ARCHITECT'S PROJECT NO: 98-2412

PROJECT: New Dental Office, Dr. Carpenter
Napoleon OH 43545

To Jerry Overmier - Beilharz Architects
Fax No. (419) 782-8722
From Adam C. Hoff, P.E. - City Engineer *ACH*
Date 5/24/99
Subject Plan Review - Dr. Michael Carpenter Office
Pages 1, including this one

To Jerry Overmier - Beilharz Architects
Fax No. (419) 782-8722
From Adam C. Hoff, P.E. - City Engineer *ACH*
Date 5/11/99
Subject Plan Review
Pages 1, including this one

Model 975XL 3/4" - 2"

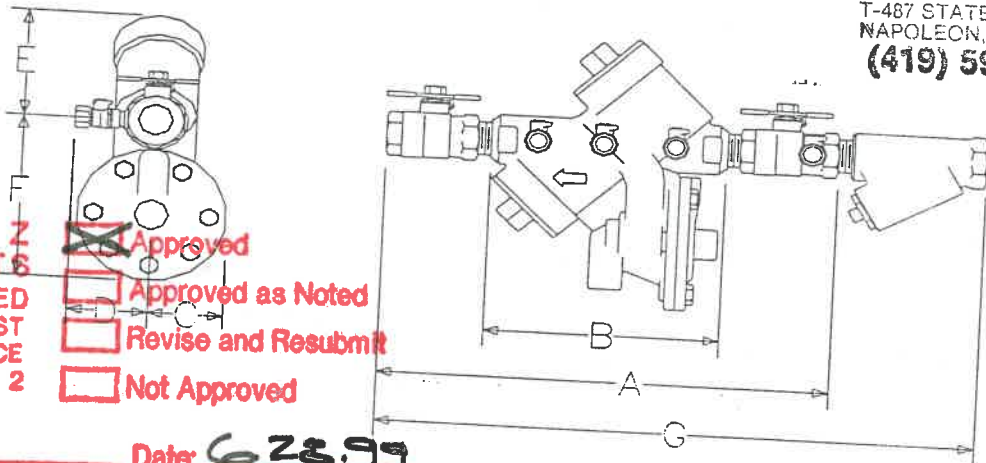
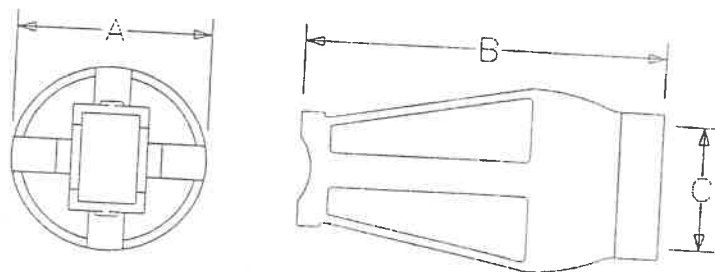
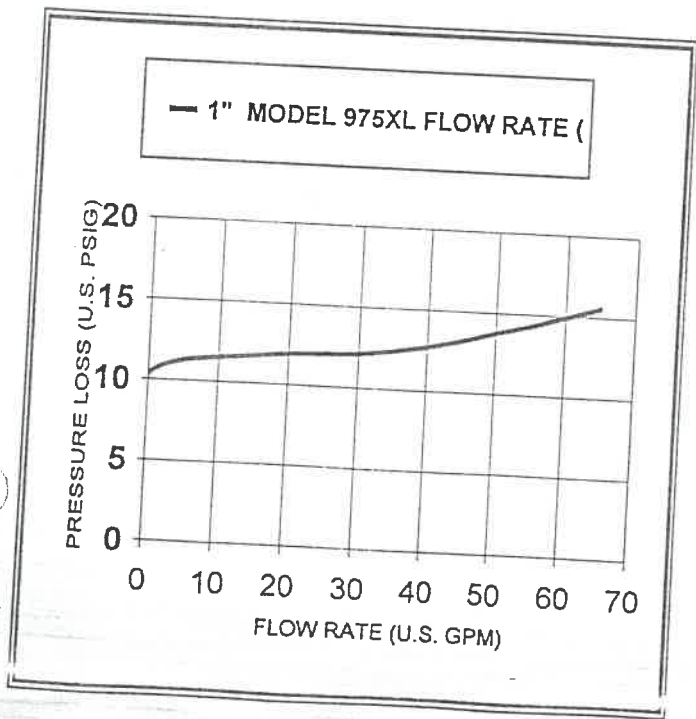
- Approved
- Approved as Noted
- Revise and Resubmit
- Not Approved

By: *[Signature]* Date: 6-28-99
